Alexandra and Ainsworth Estate Tenants and residents' Association

Planning Applications
2024/0091/L
2023/5338/P
2023/5339/P

LETTER OF OBJECTION to Planning Application 2023/5338/P and Listed Building Consent 2024/0091/L.

Site Address: Alexandra Road Estate, Rowley Way, London NW8 0SN

Photo of the existing concrete fins from report

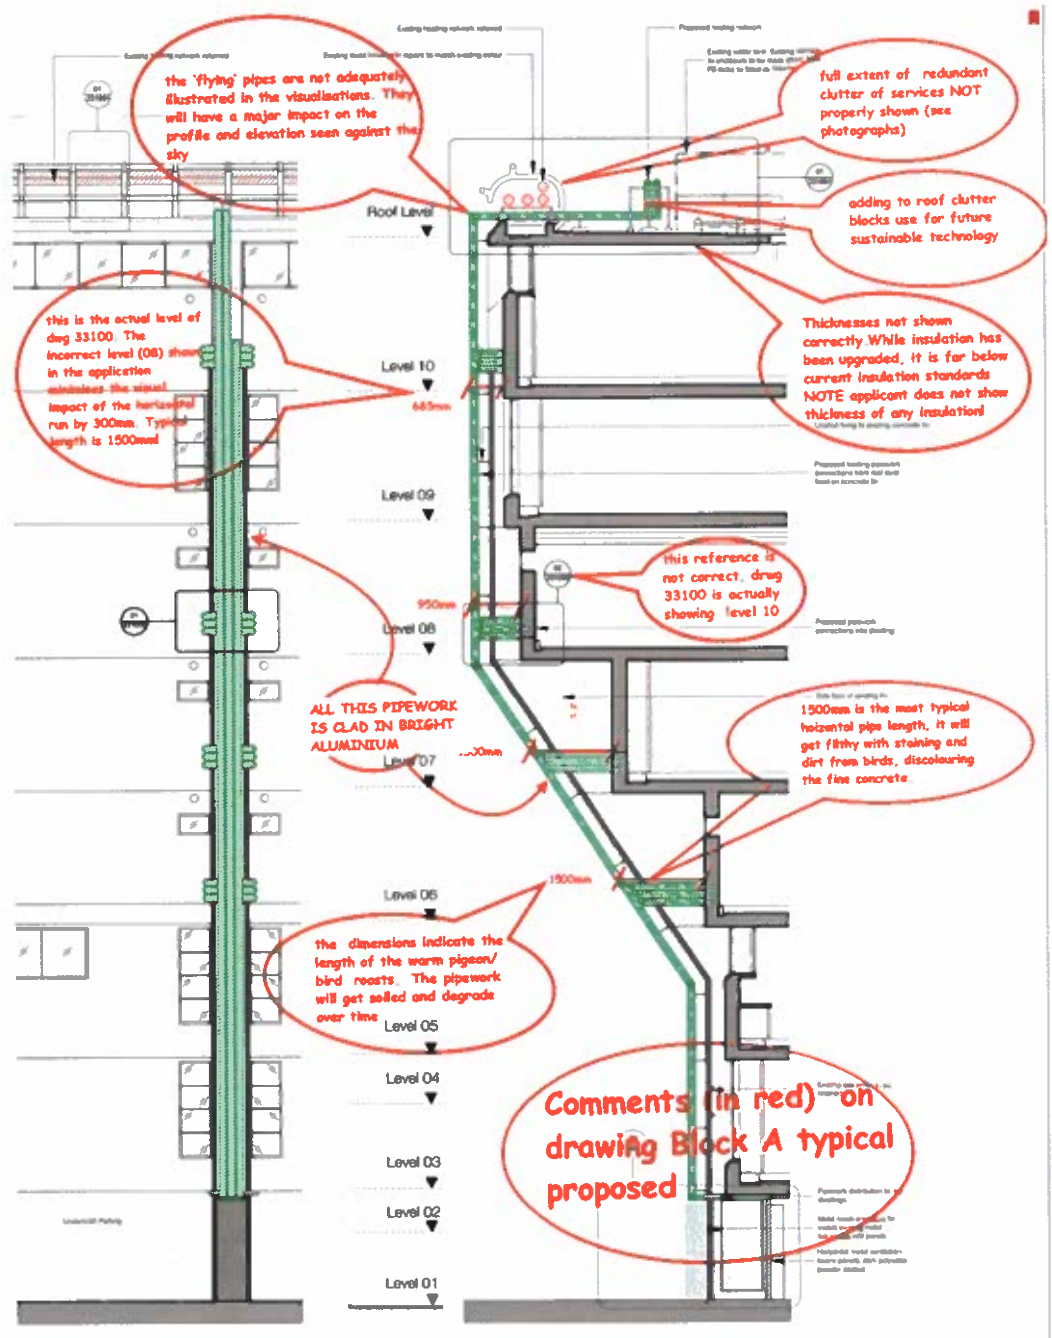
d) **Block A – north elevation**

This is the iconic view, that thousands of people enjoy every day.

The illustrations are misleading as they only show a view from the low-level service road. The angle of view also masks the awkward disfiguring set back at the top floor which will have a huge visual impact when seen from the public realm.

The elevation will be radically and irreversibly altered, and heritage destroyed.

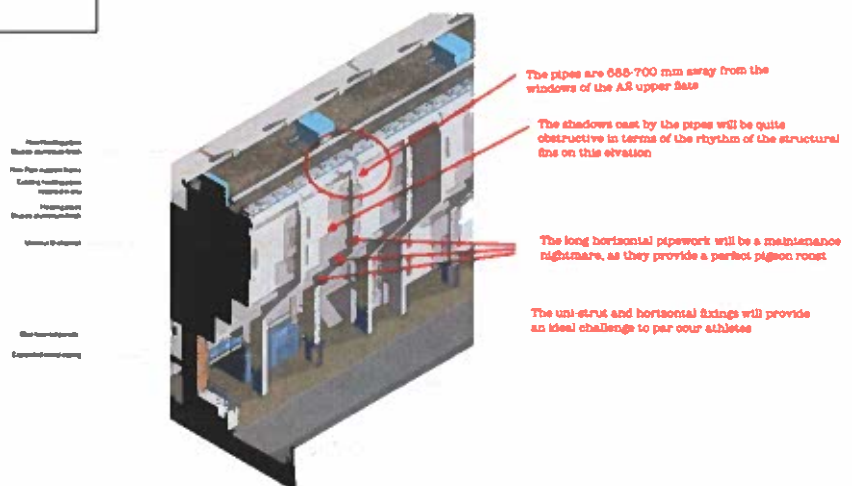
- h) The applicant's Technical Report (in fig 3.6) shows that the existing pipework to Block A is 'externally visible'. However, while this is literally true in that the pipe work is visible at low level to someone walking under the building in the car parking area or on the roof! This shown in the report in figure 3.9. Claiming it is visible underemphasises and misrepresents the changes proposed. This is disingenuous.

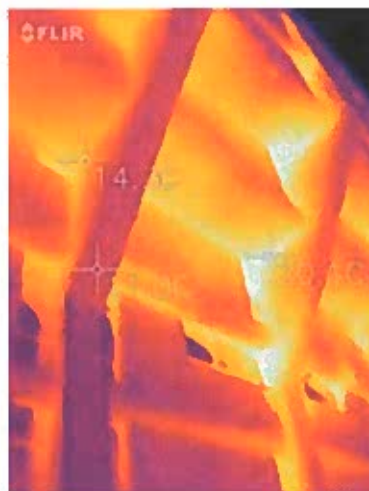
Kitchens only have opening windows.

Undoubtedly to avoid the predicted issue of damp and mould, no doubt additional mechanical ventilation will be required and further changes will be sought. The current approach does not seem to have considered the issue fully appears to be a solution of dubious technical merit.
